Access Compliance Report

Public Rights-of-Way

Intersection ID: 13388	Main Street: S_CHURCH_ST	Cross Street: W_SUMMIT_AV	Location:	N
ADA ID: 437836D3EA15	Ramp Type: PerpDiag	Initial Pass/Fail: Fail	Overall Compliance: No	Severity Score: 37.5

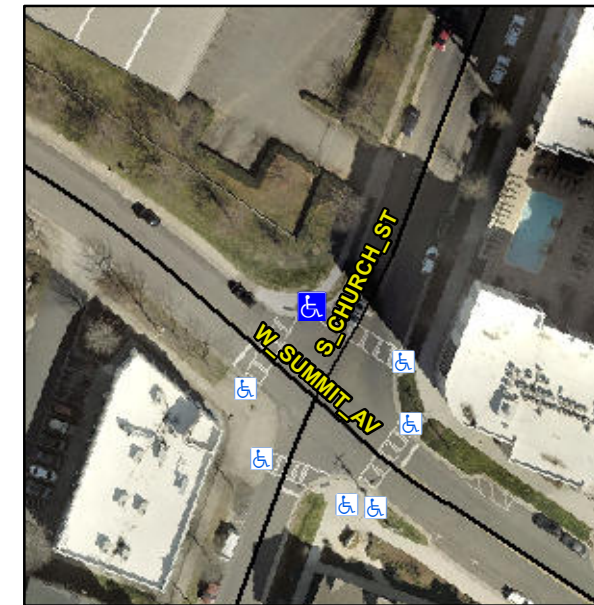
Not Found, R304.2.2, R304.5.3

Compliance	Description	Data	Compliance	Description	Data
N/A	Ramp Length (in)	95.0	No	Ramp Slope (%)	9.0
Yes	Ramp Width (in)	107.0	No	Ramp XSlope (%)	10.1
N/A	Flare Type LT	N/A	N/A	Flare Type RT	N/A
N/A	Flare Slope LT (%)	N/A	N/A	Flare Slope RT (%)	N/A
N/A	Flare Traversable LT?	N/A	N/A	Flare Traversable RT?	N/A
N/A	Landing Length (in)	N/A	N/A	DWS Provided?	N/A
N/A	Landing Width (in)	N/A	N/A	DWS Contrast?	N/A
N/A	Landing Slope (%)	N/A	N/A	DWS Length (in)	N/A
N/A	Landing X Slope (%)	N/A	N/A	DWS Full Width?	N/A
N/A	Landing Curb? (Y/N)	N/A	N/A	DWS Offset (in)	N/A
N/A	Shared Landing?	N/A			
N/A	Gutter Ponding?	N/A	N/A	Gutter Slope (%)	N/A
N/A	Gutter Lip Ht (in)	1.5	N/A	Gutter X Slope (%)	N/A
N/A	Painted X Walk1?	No	N/A	Painted X Walk2?	No
	X Walk 1 Direction	To SW		X Walk 2 Direction	To SE
N/A	X Walk 1 Width (in)	N/A	N/A	X Walk 2 Width (in)	N/A
	X Walk 1 Slope (%)	10.0		X Walk 2 Slope (%)	0.7
	X Walk 1 X Slope (%)	1.7		X Walk 2 X Slope (%)	8.0

Remove & Replace Curb Ramp With Two New Directional Ramps or Equivalent.
